RE: **Lot 9, Blk 1 Cliffs Unit 22 SAD 228**
8012 Alto Rey Ct. NW
Grading and Drainage Plan
Engineers Stamp Date 10/29/2020 (D10D003N9)
Pad Certification Date: 3/11/2021

Based upon the information provided in your submittal received 4/19/2021, this plan is approved for Building Permit.

SHEET TITLE:
GRADING AND
DRAINAGE PLAN

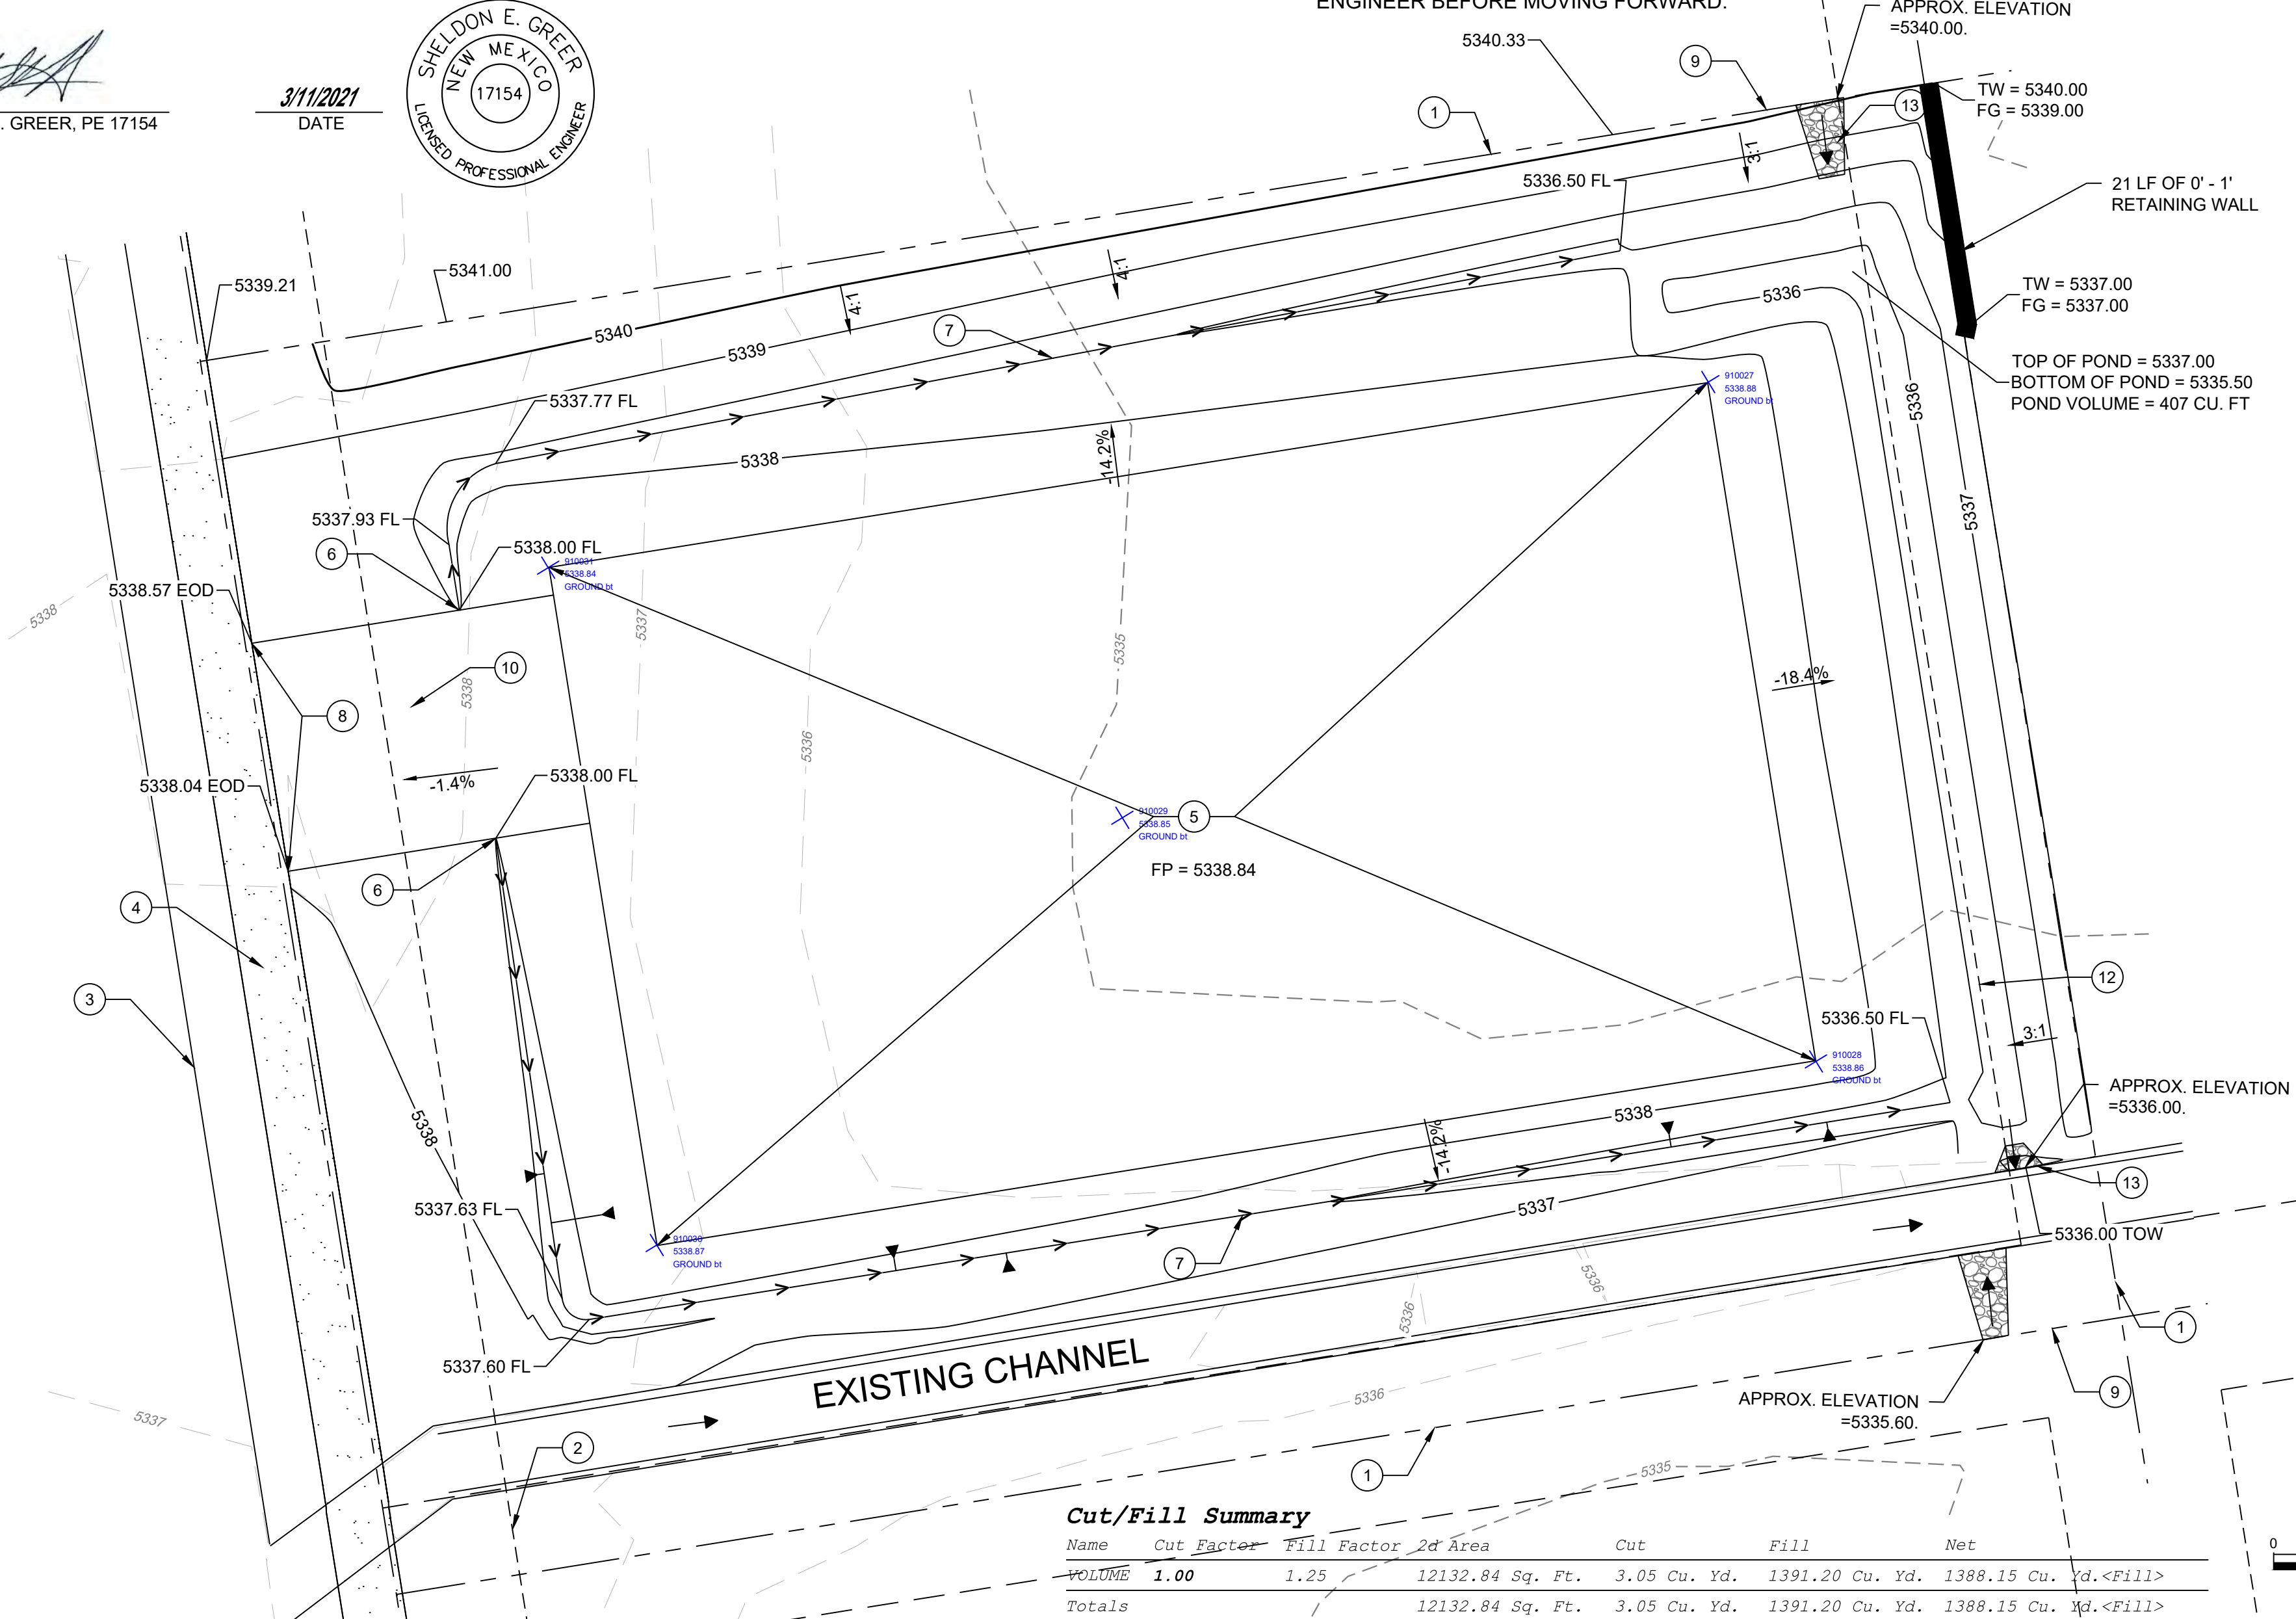
Prior to Building permit approval a Pad Certification will be required, provided by the Engineer or a registered Land Surveyor.

Reiterate to the Owner/Contractor that a separate permit for a garden/retaining wall must be obtained with the approved G&D plan and Pad Certification. **Also, if a swimming pool is to be placed the grading and drainage plan will change and will need to be resubmitted.**

Prior to Certificate of Occupancy release, Engineer Certification per the DPM checklist will be required.
